7ELEVEN AT WALLBROOK (LOT 11)

SITE DEVELOPMENT PLAN

US-401 Business / S. Main Street ~ Wake Forest Township ~ Town of Rolesville ~ Wake County ~ North Carolina

COVER - OVERALL SITE PLAN
7ELEVEN AT WALLBROOK (LOT 11)
Town of Rolesville Project No. SDP 23-
US 401 Business / S. Main Street & Virginia Water Drive
Wake Forest Township, Town of Rolesville, Wake County, North Carolina

REQUIRED VEGETATION PLAN
7ELEVEN AT WALLBROOK (LOT 11)
 Town of Rolesville Project No. SDP 23-____
 US 401 Business / S. Main Street & Virginia Water Drive
 Wake Forest Township, Town of Rolesville, Wake County, North Carolina

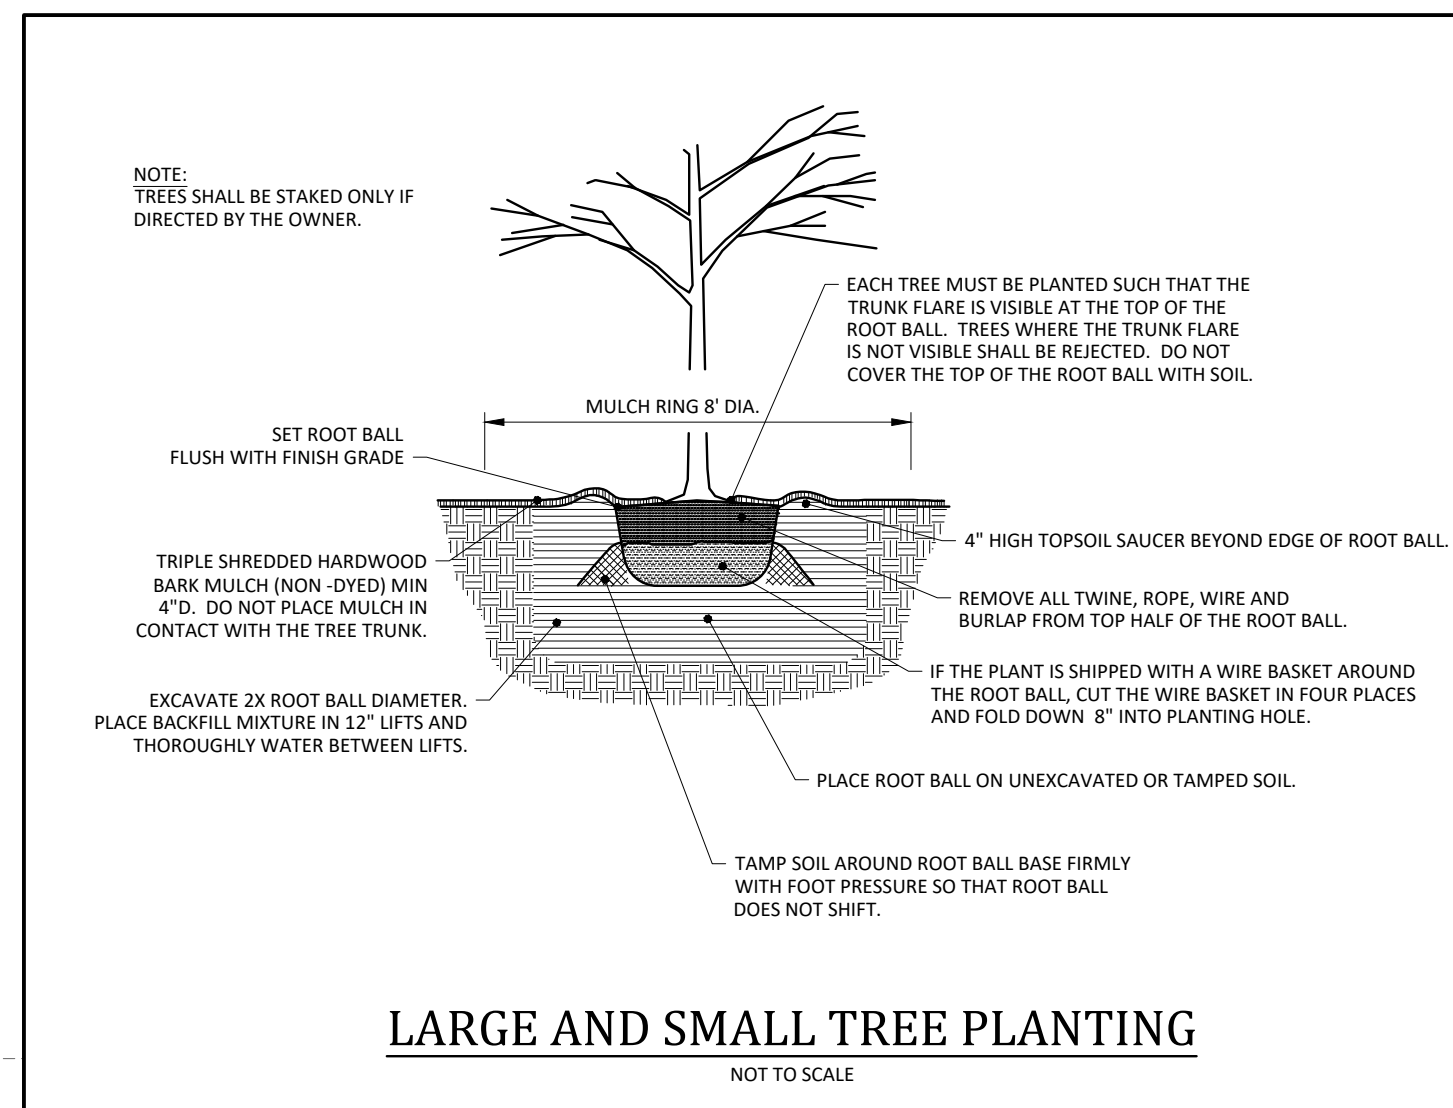
Label location of shrubs as well as provide a total count.

LOCATION AND COUNT ADDED

Sheet Number:
R1.00

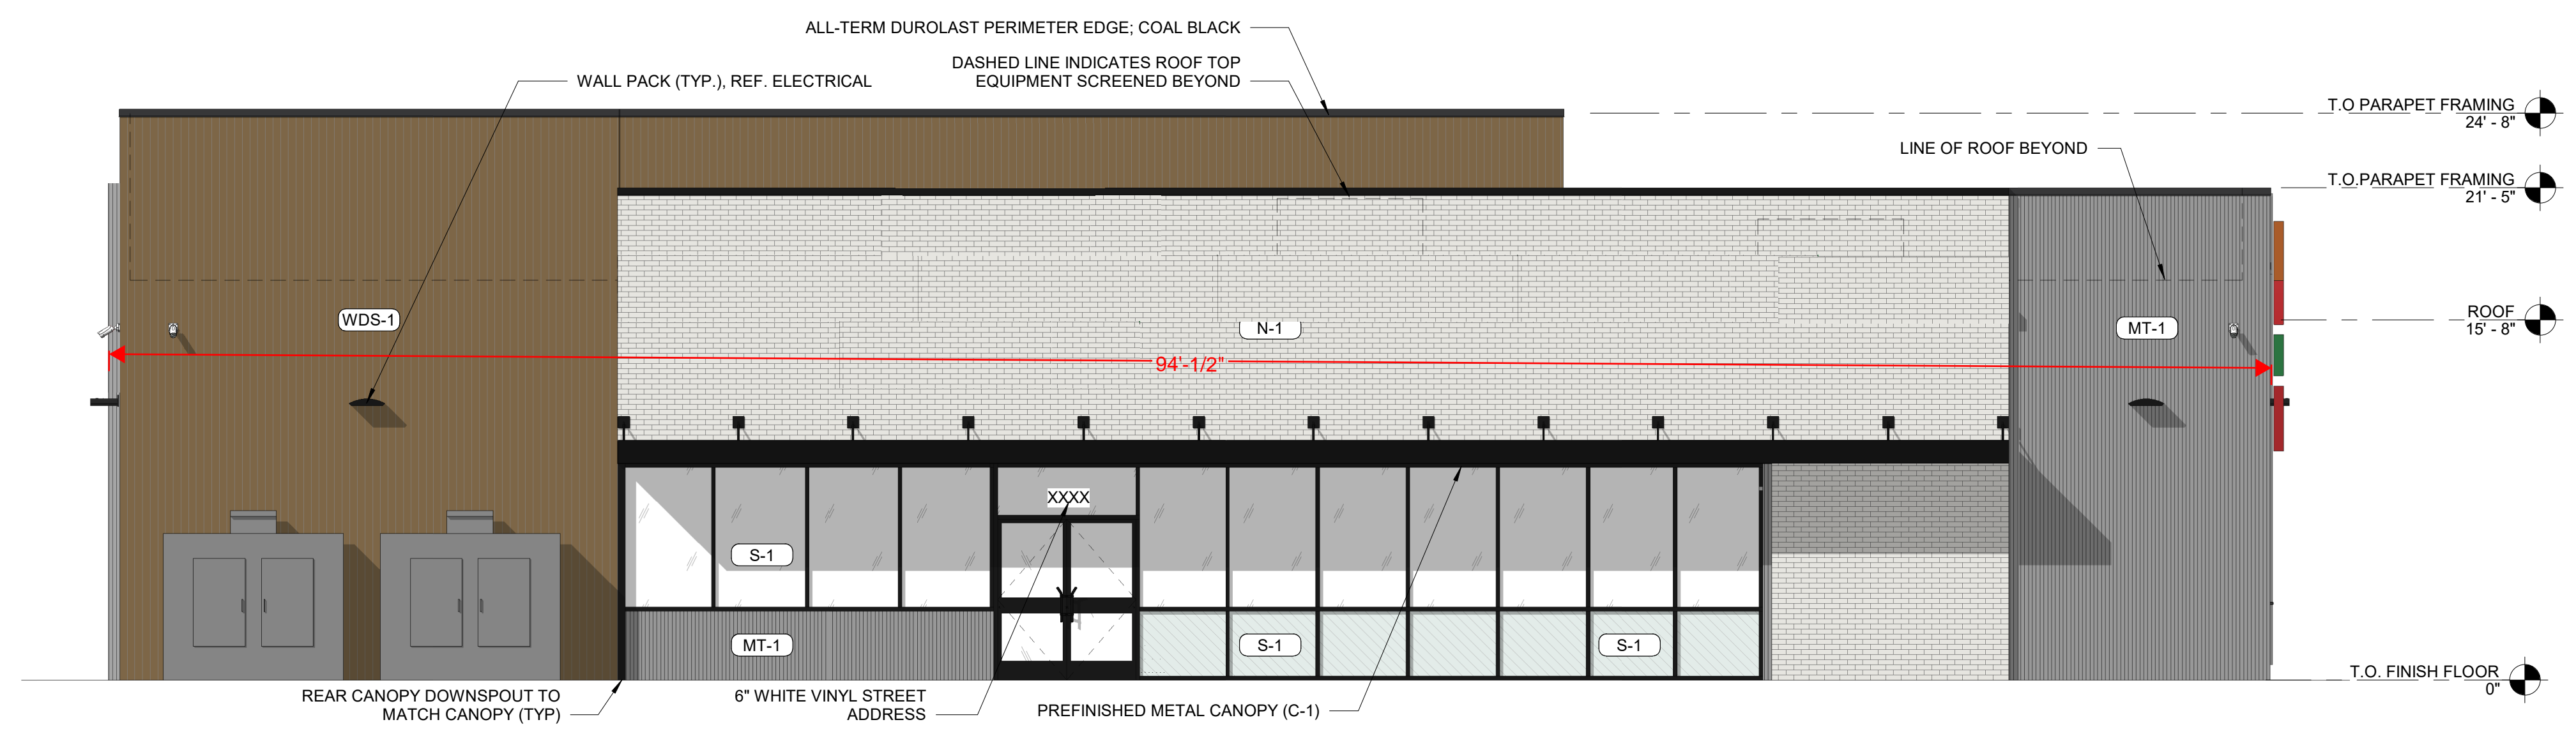
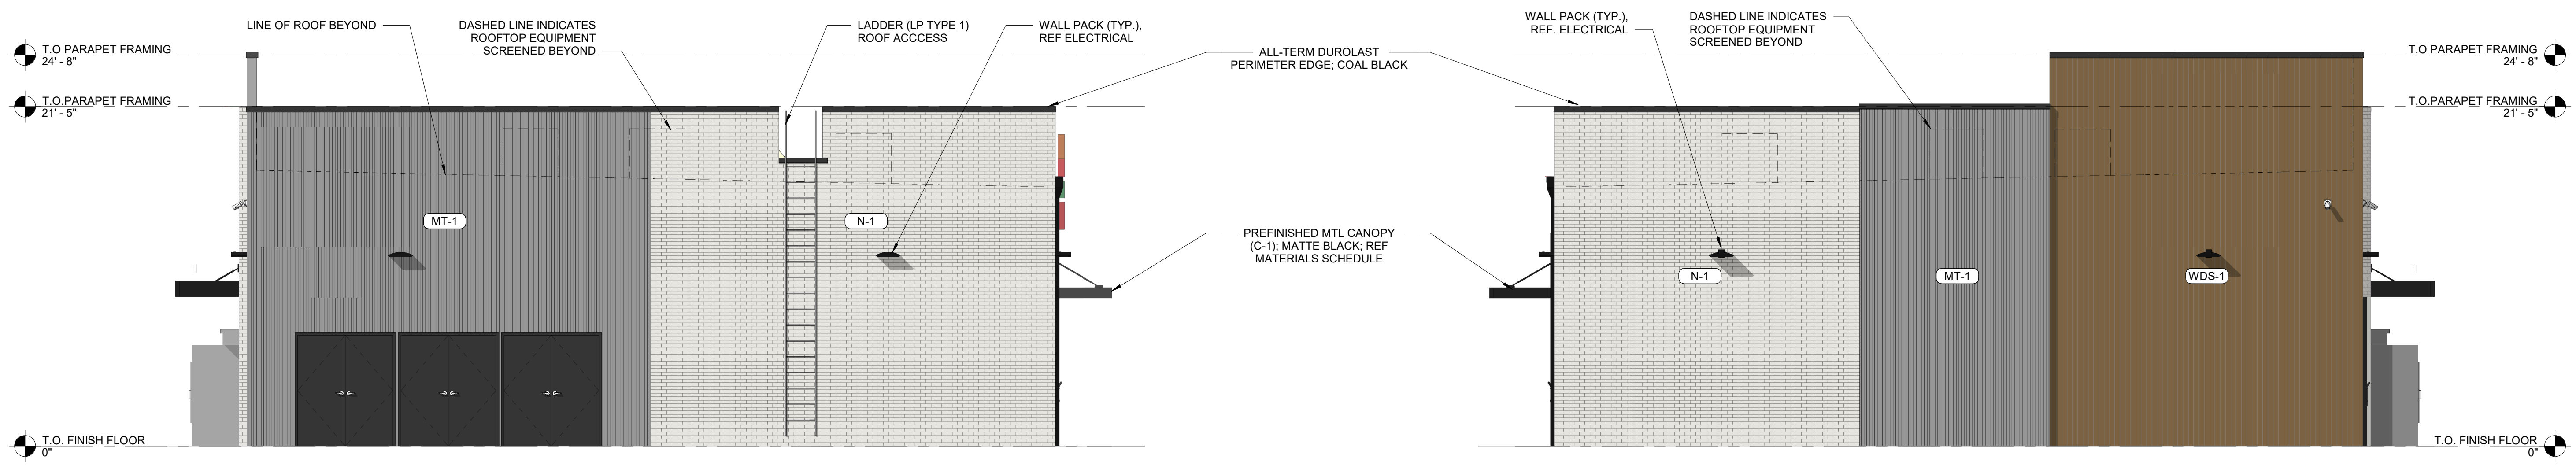
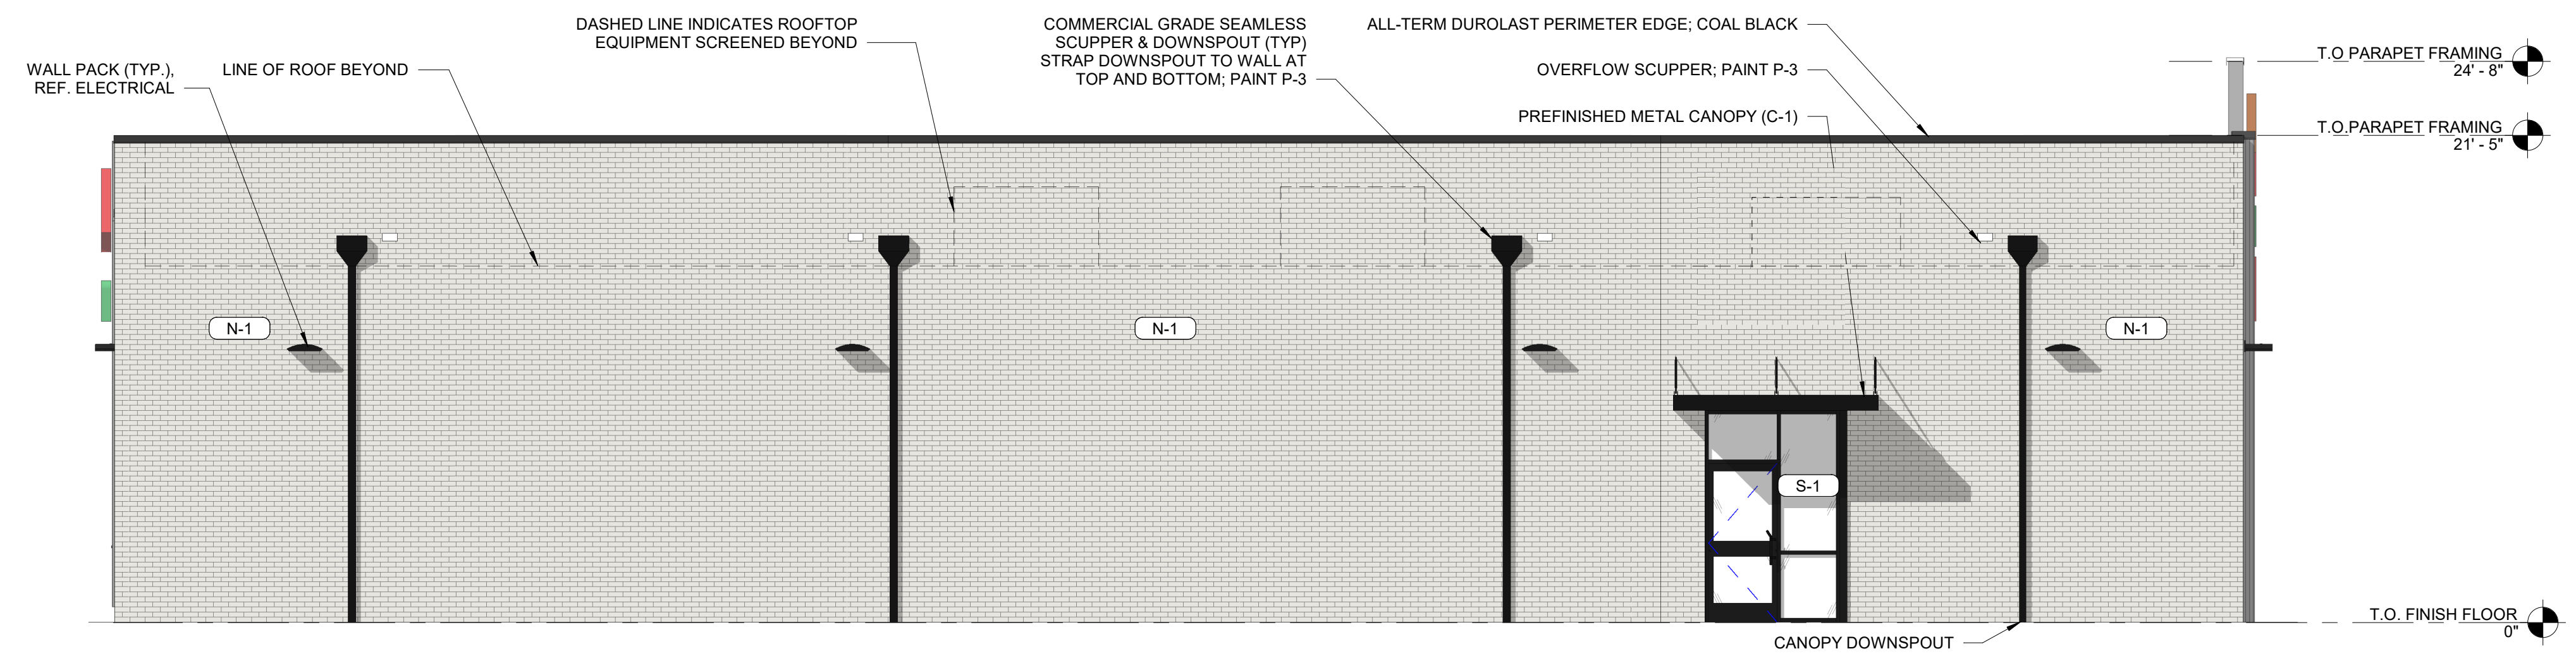
LDO Section 6.8.3.D.1.d notes that facades of 60 or greater feet in width shall incorporate wall offsets of at least one (1) foot of depth of every forty (40) feet. Illustrated as "D" in Figure 6.8.1.

Vinyl siding, smooth untreated concrete block, metal siding, faux stucco, and plastic materials are prohibited building materials.

ELEVATIONS REVISED ACCORDINGLY.

ELEVATIONS REVISED ACCORDINGLY.
